EXHIBIT E

Title		Optimiser USB ADSL Modem
Document Number		
Scale	Block diagram	
Date	Thursday, February 17, 2000	Sheet 1 of 9
Rev	G

Block Diagram

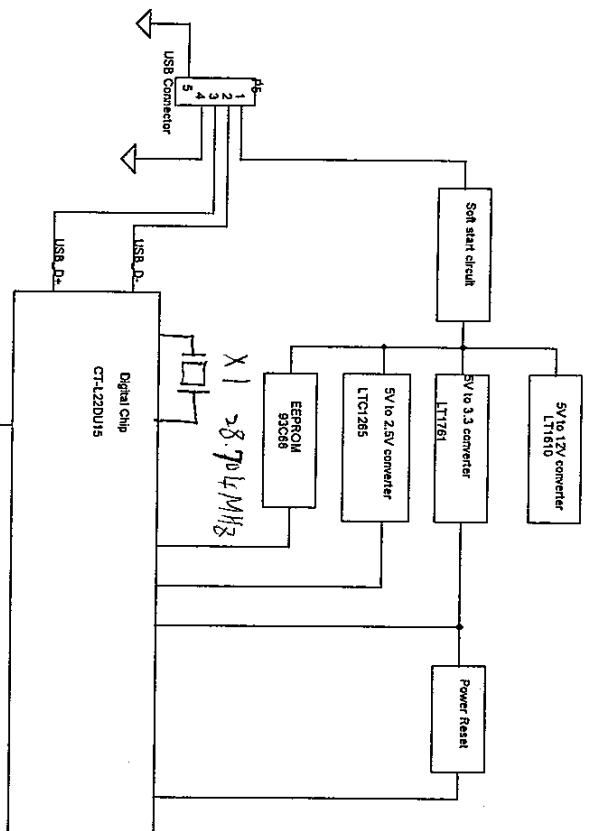
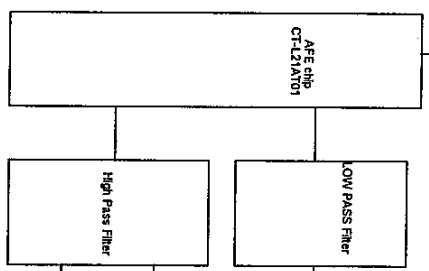
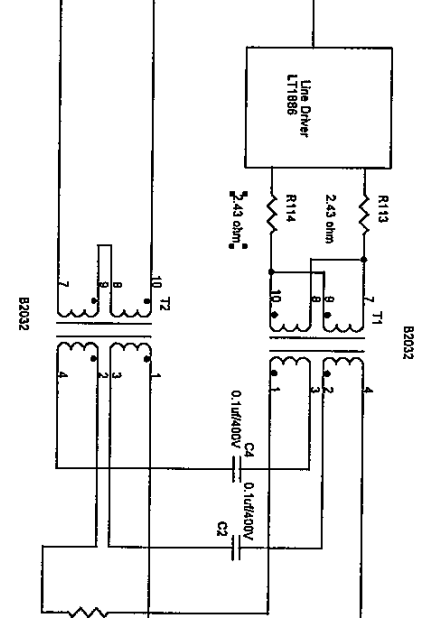
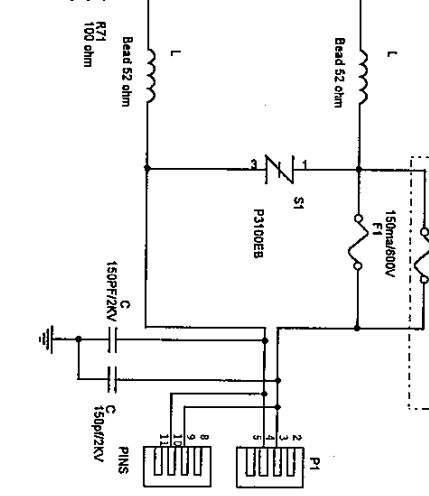
Rev D : for PA2150001001
 Rev E : PCB PA2150001001 with EEPROM rework (see page 5)
 Rev F : PCB PA2150001003 with EEPROM ECN (see page 5)
 Rev G : PA2150001005 (EMI modification) ----
 Page2 -- add I19~23 , C169,C172
 Pages -- add , L25,L26,C170,C171
 C42,C43,C139,C140,C79 -- 22uF/16V -> 33uF/16V
